**Date:** 30.01.2026      **Affected Models:** Emira 4-Cylinder Powertrain 2024 & 2025 Model Year Vehicles      **Affected Regions:** Federal Market      **Affected Volume:** 712      **Number:** 131-26004

Fitment of tail lamp link lead harnesses to prevent indicator warning message activation.

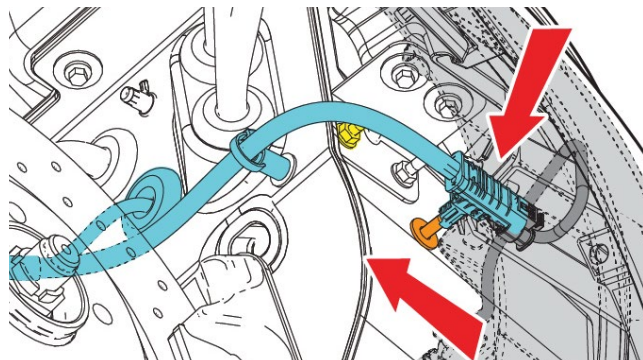
Under certain conditions the warning message shown to the right can be activated in the driver display when both the brake lamps and a turn signal are activated at the same time. The cause of this issue has been identified as the unique Federal rear lamp combined position/brake/turn indicator configuration.

RCL link leads fitted between the engine compartment harness and rear lamp connector plugs are now fitted as a production running change to resolve this issue. These can also be ordered via the parts system on the Lotus Commercial Management System (LCMS) for 2024 - 2025 model year 4-cylinder vehicles.
